Re: Village of Hoffman Estates

Village Green Concessions

Architect's Project Number: 24-002

Addendum #1

-	120210210
ERN		
FOR BID & PERMIT: 09/05/2024		
SITE DEMOLITION DIAN

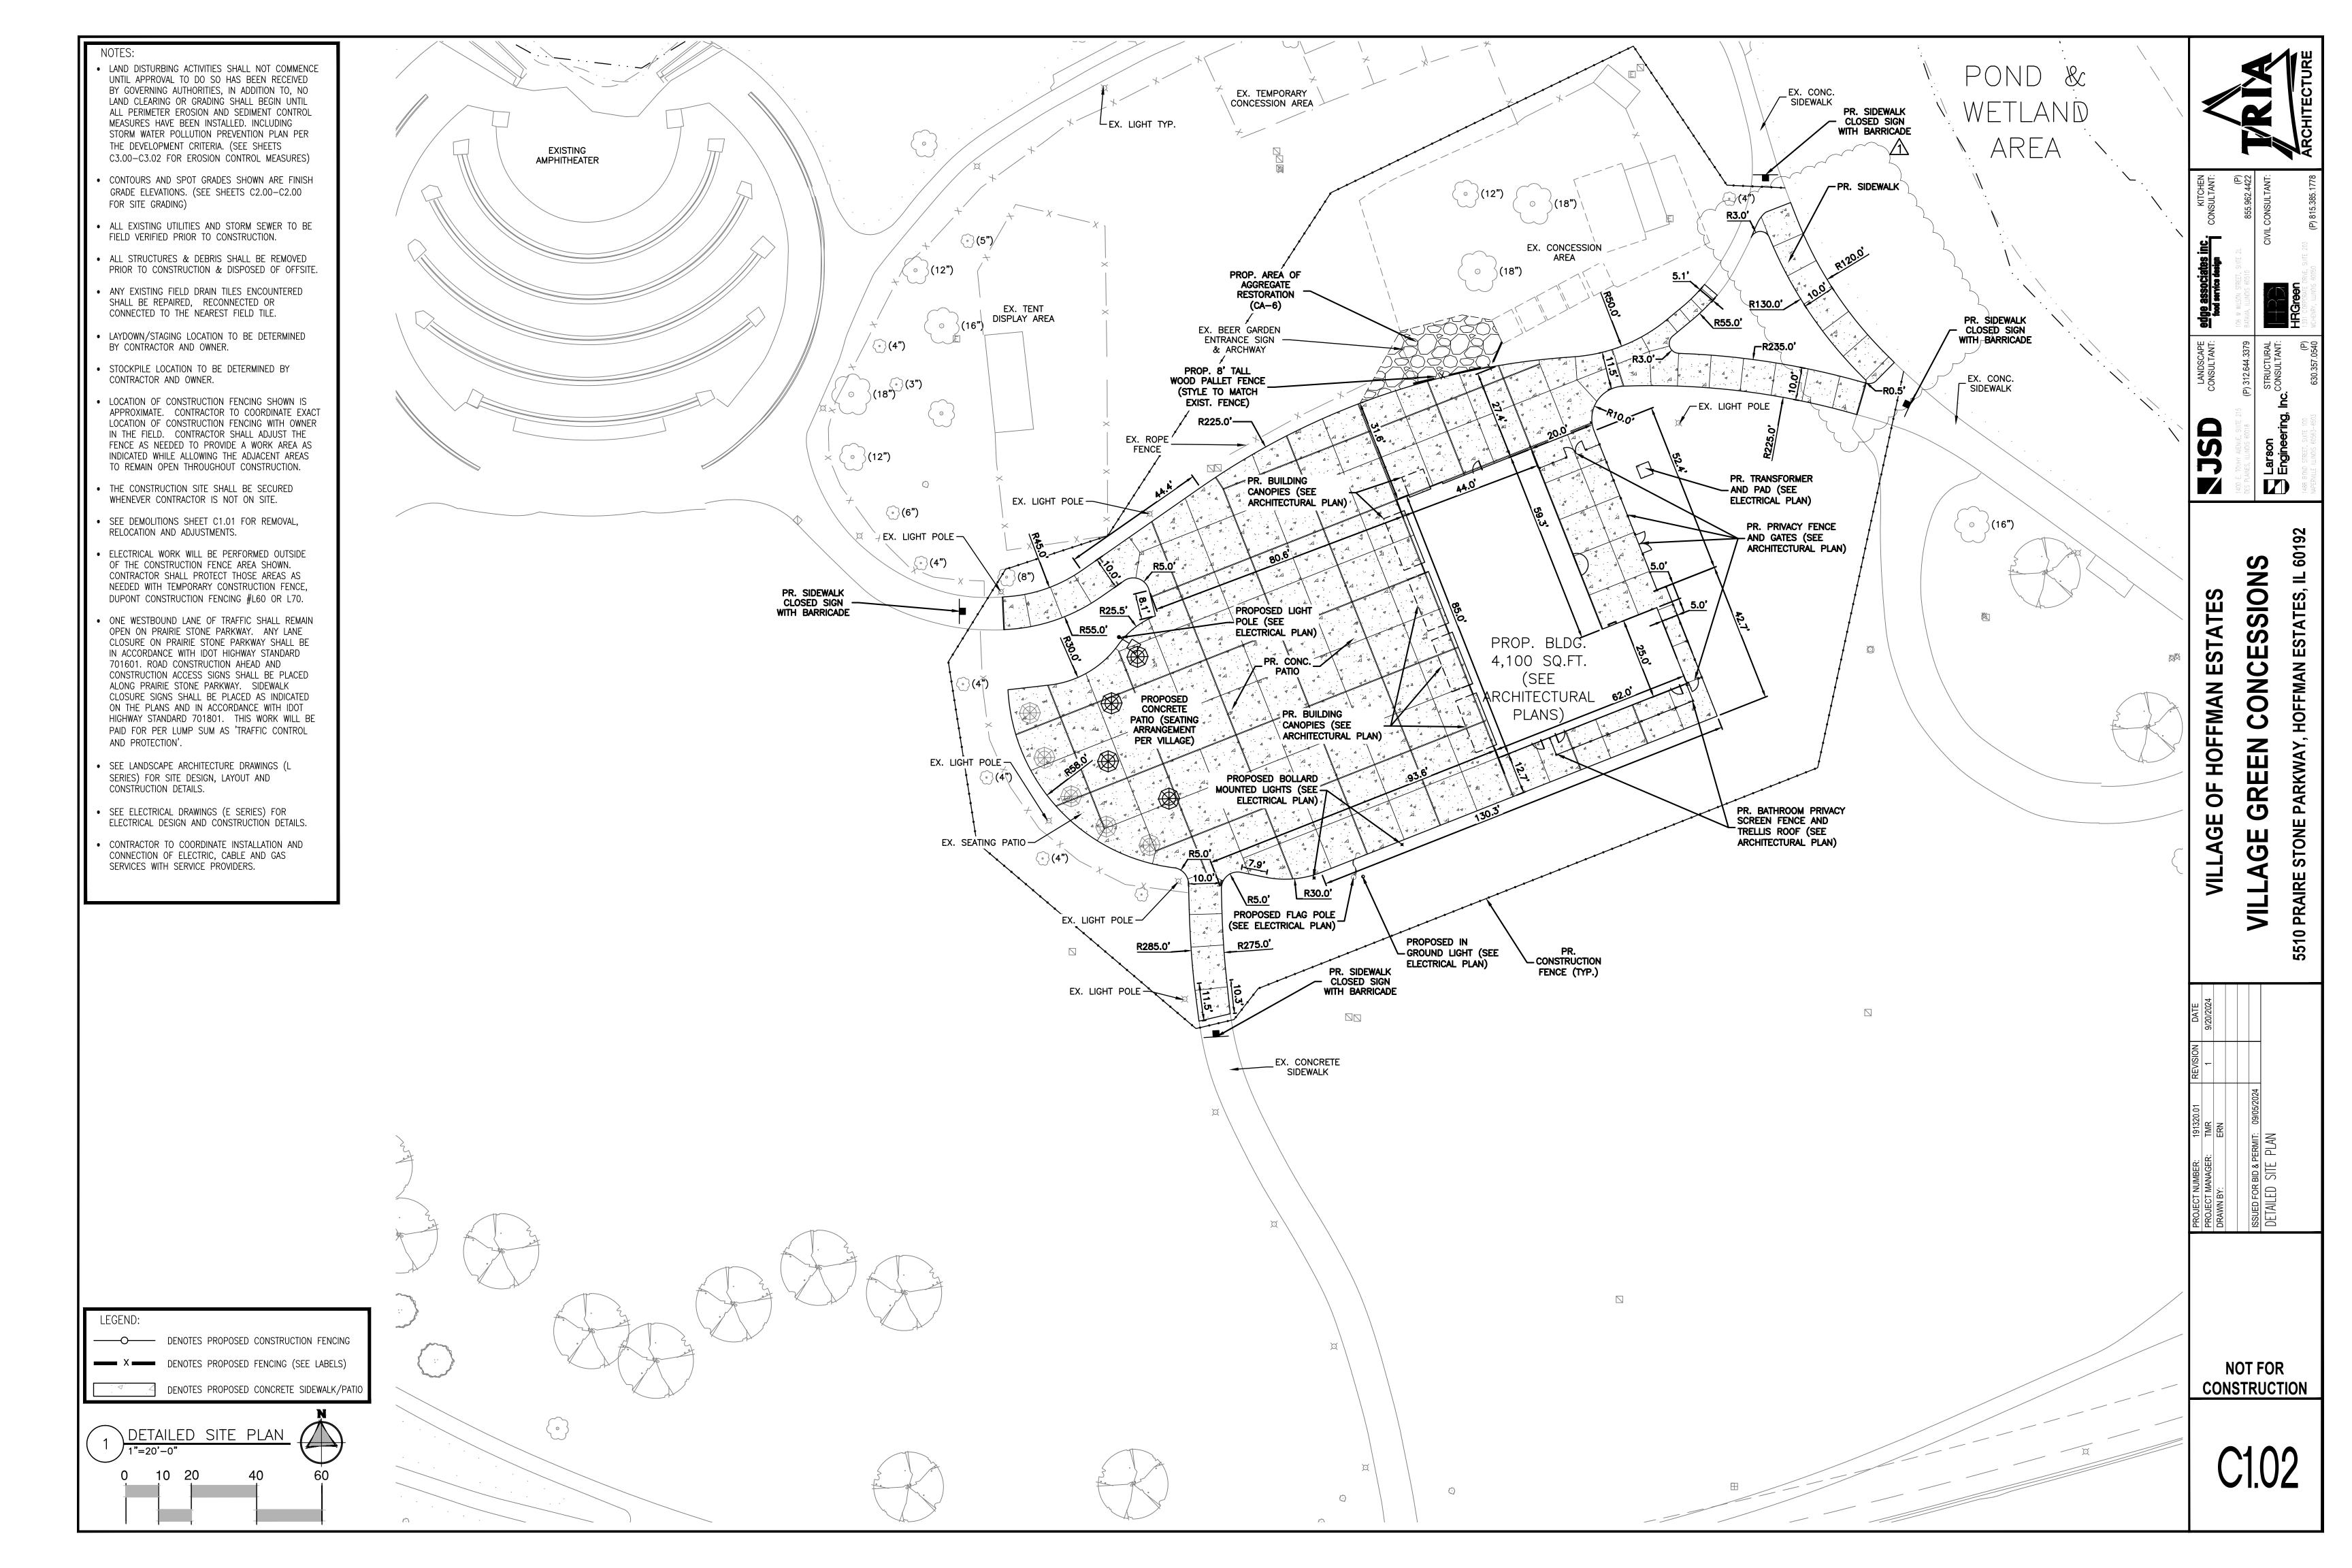
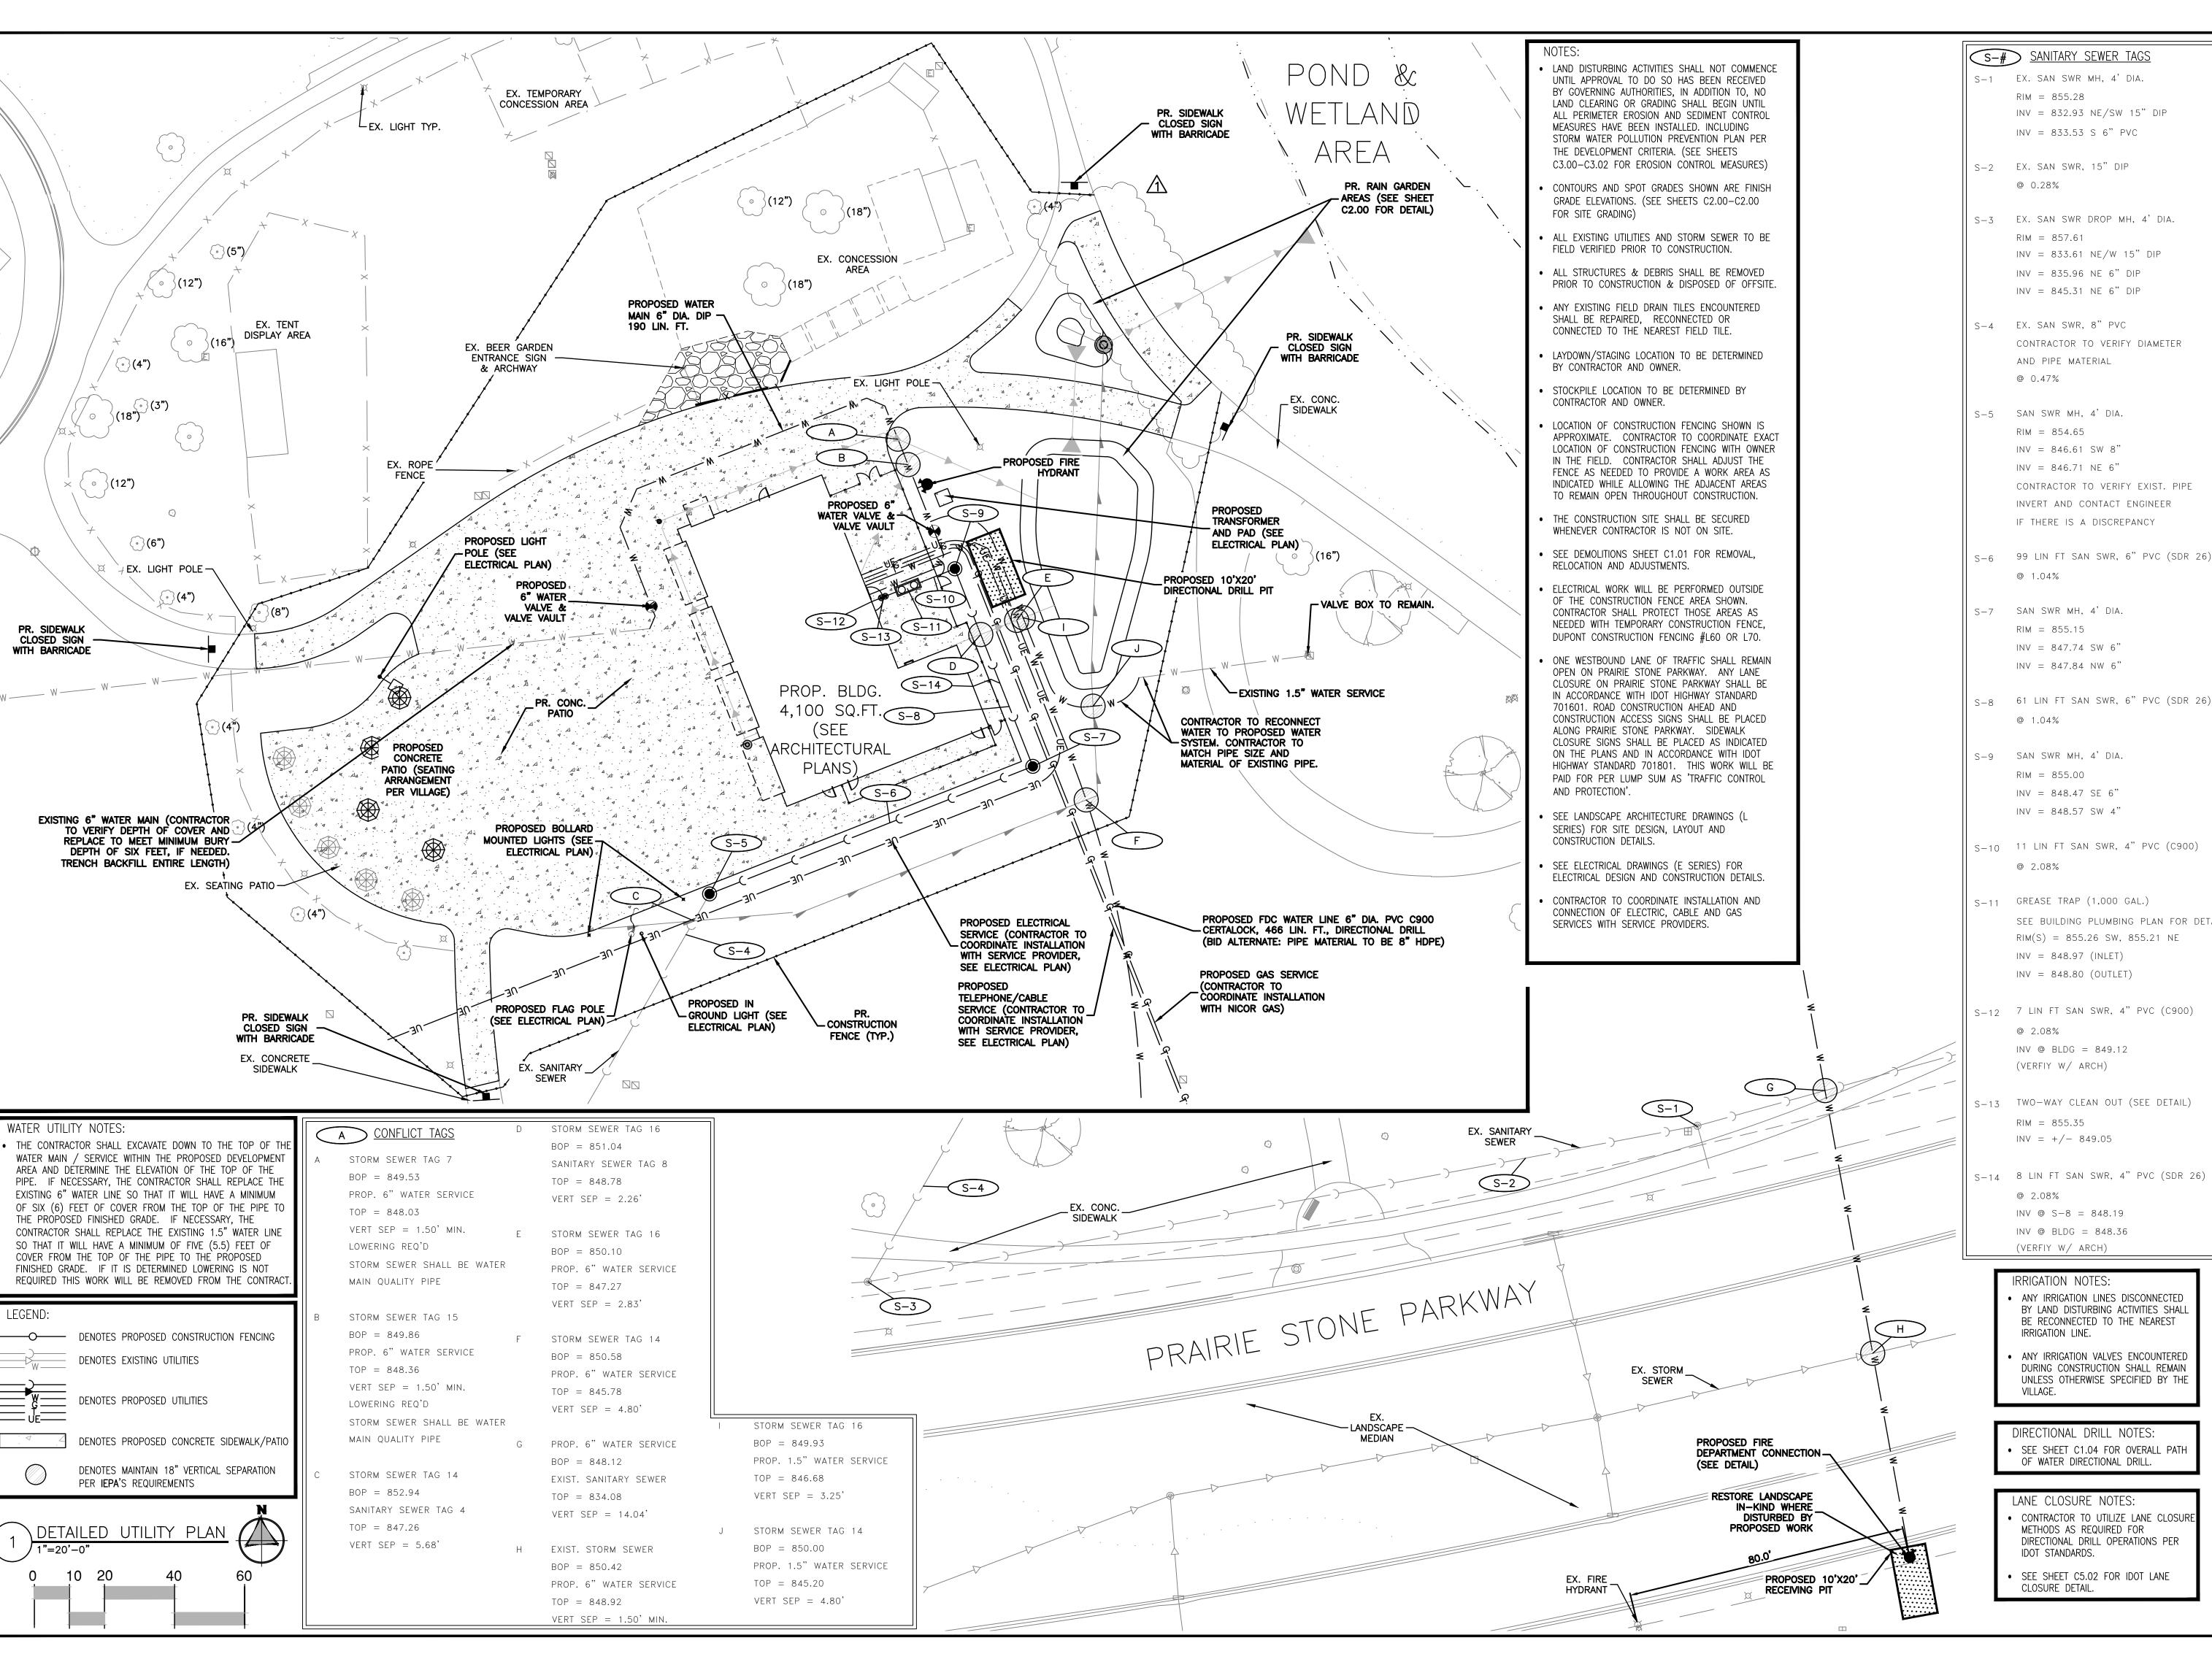
- 1. Drawing C1.01 **REVISE** as follows:
 - a. Sidewalk at northeast end of development area revised to be removed. Revision tag R-2 revised to read "Omitted" – refer to replacement drawing attached.
